LOST CREEK ISR, LLC

**Re: Lost Creek Project,
NRC License SUA-1598, Docket No. 40-9068
Amendment Application for inclusion of Yellowcake Vacuum Drying**

**Vacuum Dryer Amendment Supplement
to the
Lost Creek ISR, LLC
Technical and Environmental Reports**

FIGURE 1.5-2b
Plant Process Flow

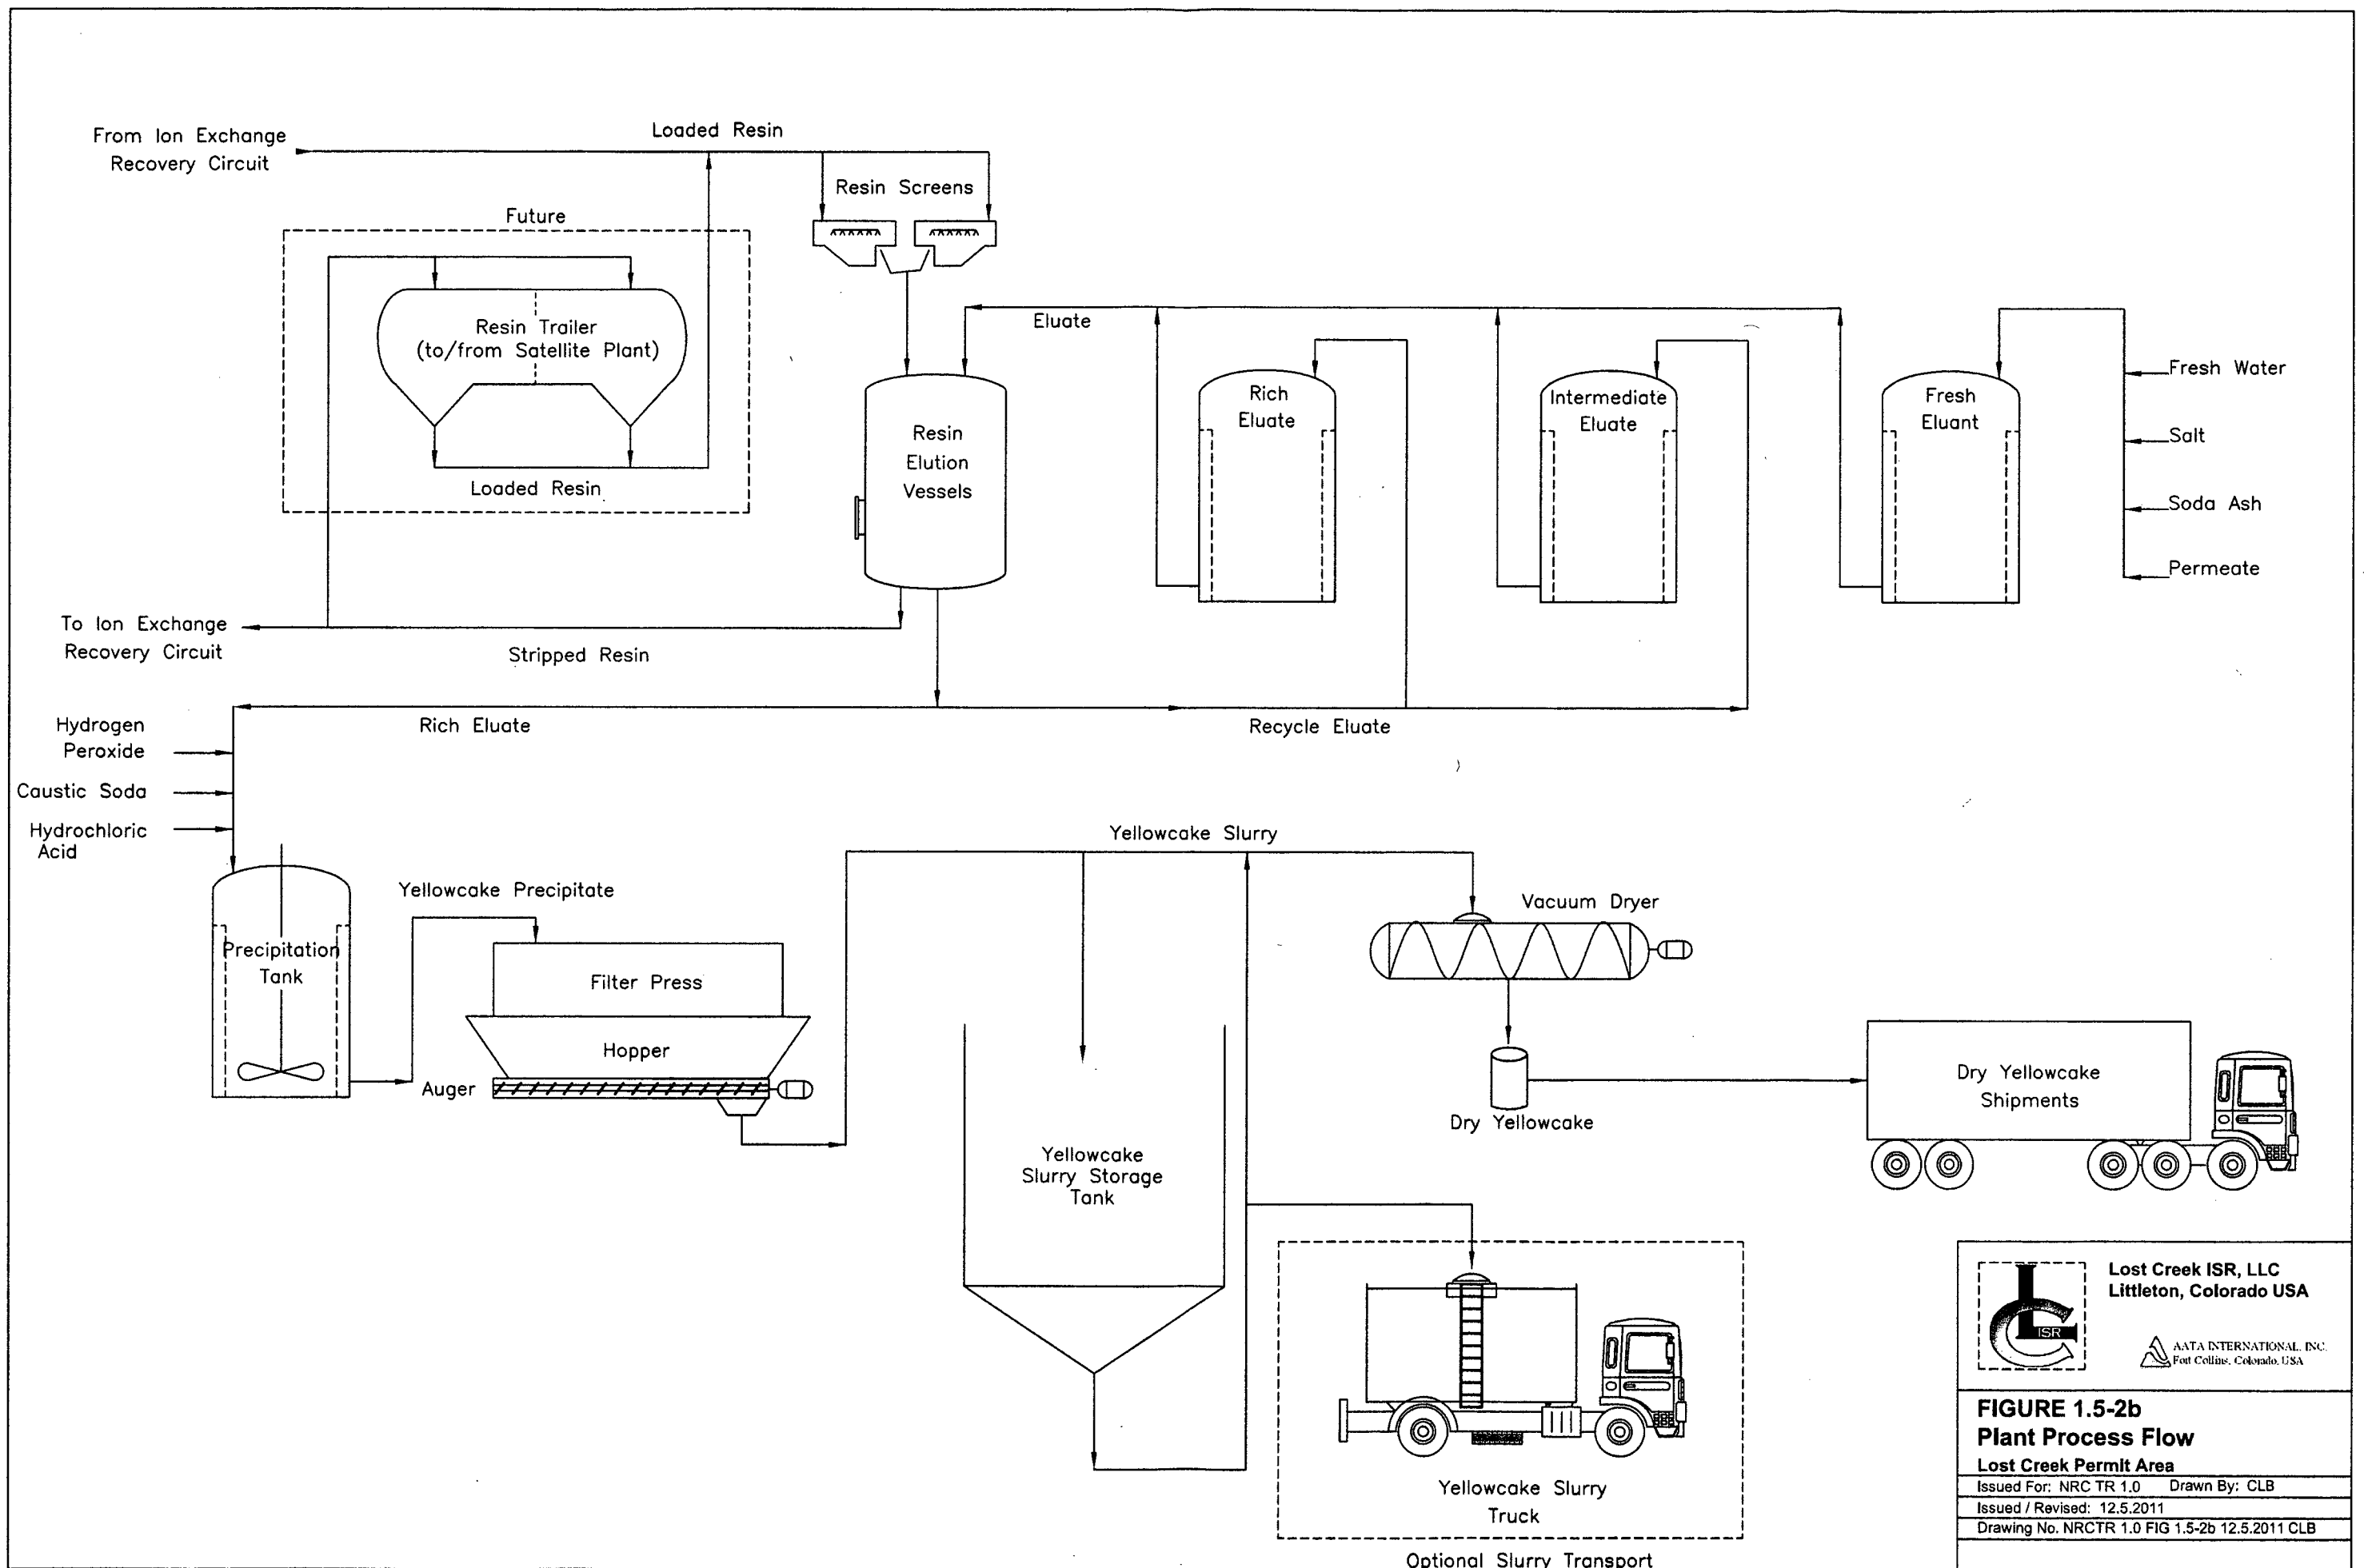
This Amendment adds a Rotary Vacuum Yellowcake Drying process to the overall recovery process as a Dryer Circuit within the Central Processing Plant (CPP). The Dryer Circuit and drying process are described in detail below in the "Supplement to TR Section 3.0 Description of the Proposed Facility". Revised Technical Report (TR) Figure 1.5-2b (Revised Environmental Report (ER) Figure 1.2-6c) is attached to illustrate the amended process.

This Vacuum Dryer Amendment hereby adds a dryer circuit to the CPP design and plant operations. The dryer circuit supplement for this ER Section is provided above in "Supplement to TR Section 3.0 Description of the Proposed Facility". Revised TR Figure 1.5-2b is attached to show the amended CPP process including the dryer circuit. Thus Revised TR Figure 1.5-2b supersedes ER Figure 1.2-6c. Revised TR Plate 3.1-1 is attached to show the amended CPP layout including the dryer circuit. Thus Revised TR Plate 3.1-1 supersedes ER Plate 1.2-1.

Dryer Flow Diagram Lost Creek Permit Area

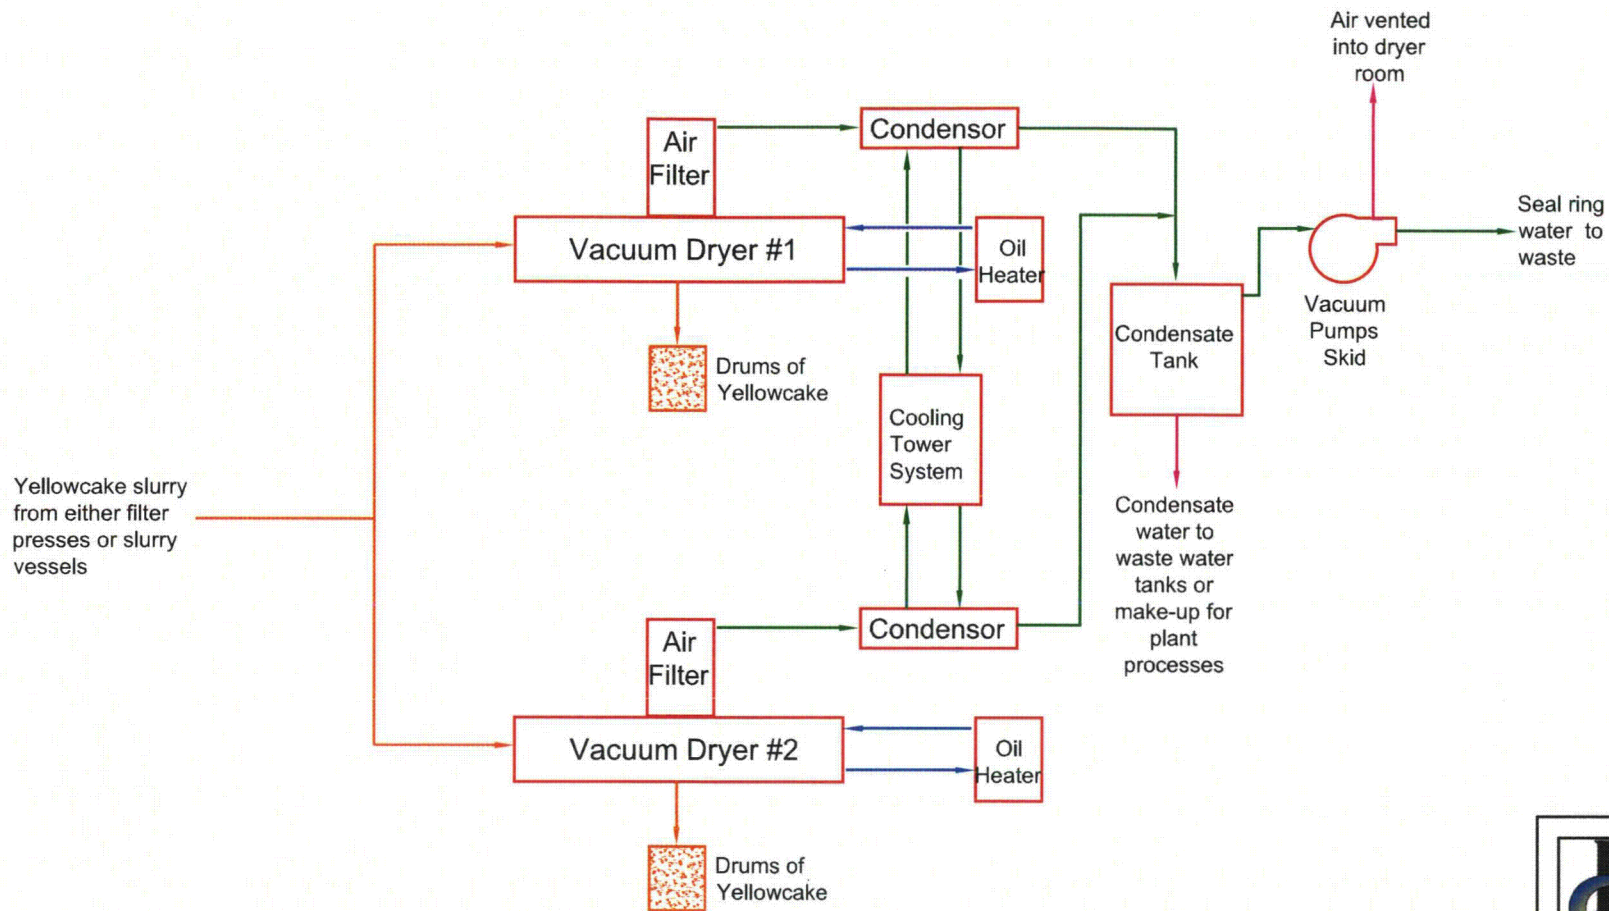
The Lost Creek Plant drying circuit will be comprised of up to two separate drying systems. This allows the plant operations department flexibility to vary the output of dried product in the case of increased production rates or changes in scheduled maintenance. The dryers will be a standard rotary vacuum design. The dryer room in the CPP will have its own ventilation system in order to prevent any dry yellowcake particulate from being circulated into other areas of the plant. The dryer circuit ventilation design provides the dryer room with negative pressure, forcing flow into the room. Vacuum dryers are designed to have no emissions. The attached "Dryer Flow Diagram" illustrates that the vacuum drawn through the dryer passes through a bag

filter, a condenser, vacuum pumps with a water seal and a condensate tank. There will not be a discharge stack associated with the dryers and final venting from the vacuum pump will be back into the dryer room.

FIGURE 5.7-1 LOCATIONS OF IN-PLANT RADIOLOGIC SAMPLING

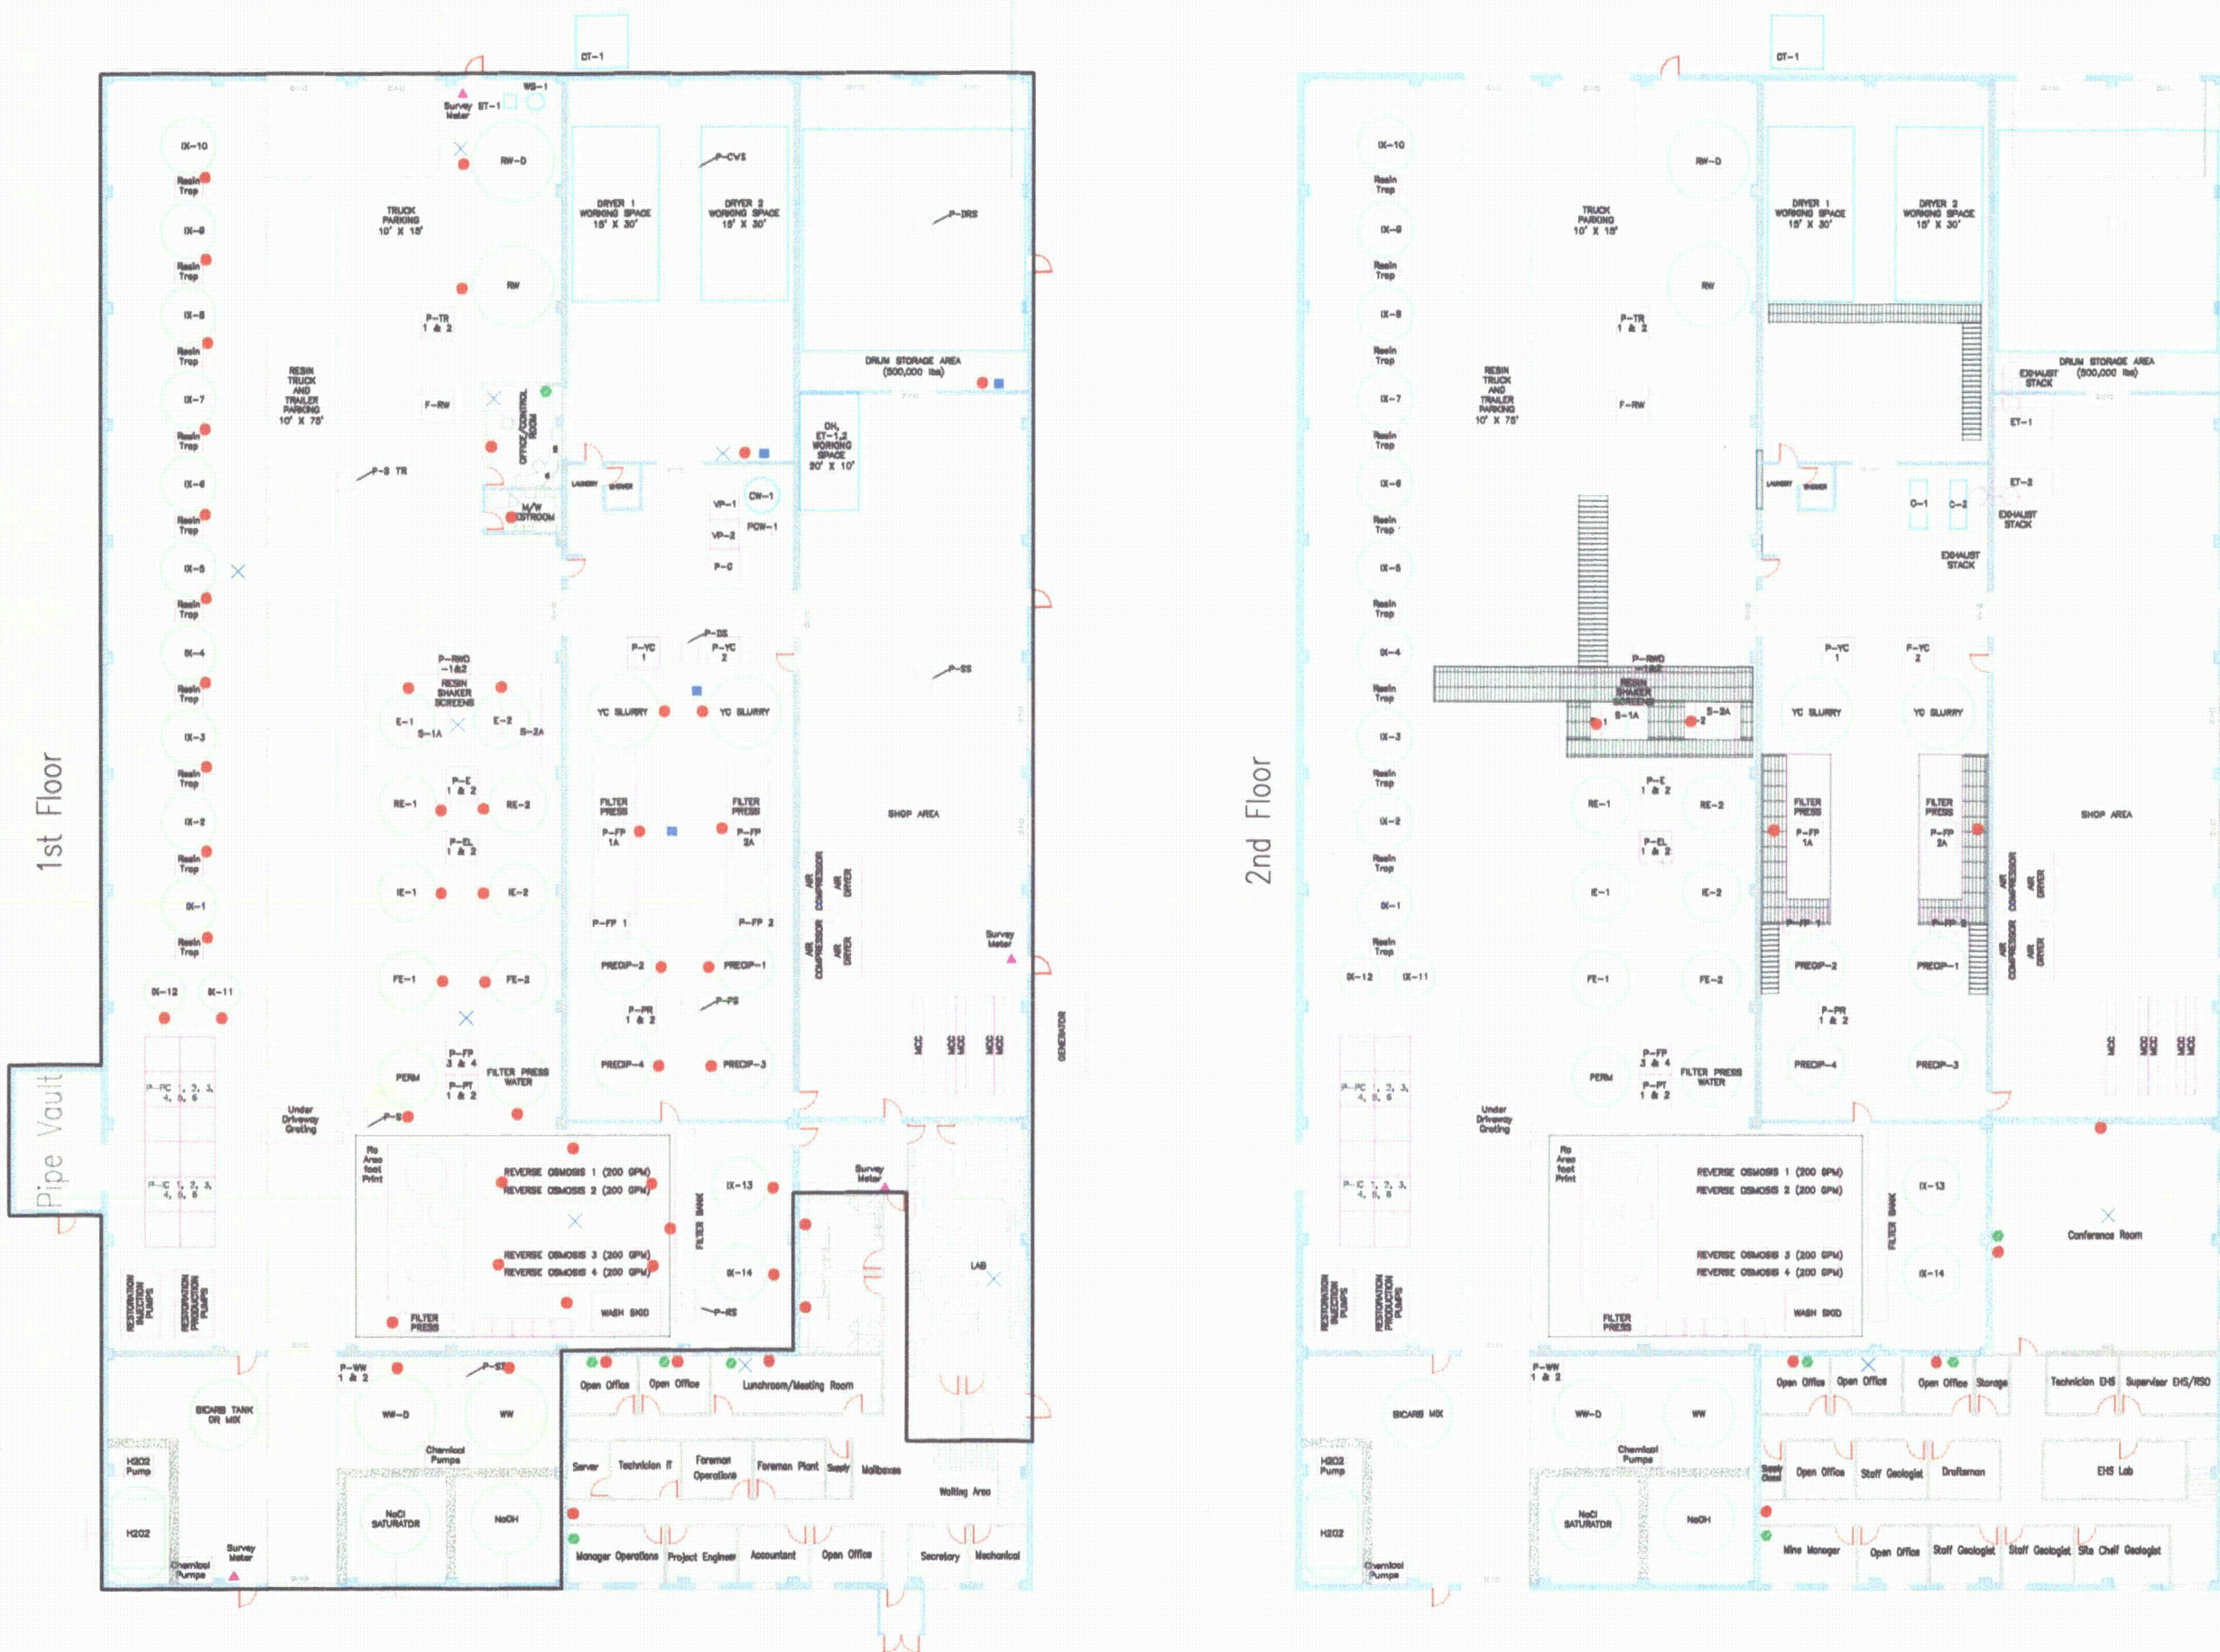
TR Section 5.7.6.2 is expanded to include the yellowcake drying area as one of the survey areas of concern where work with uranium is performed.
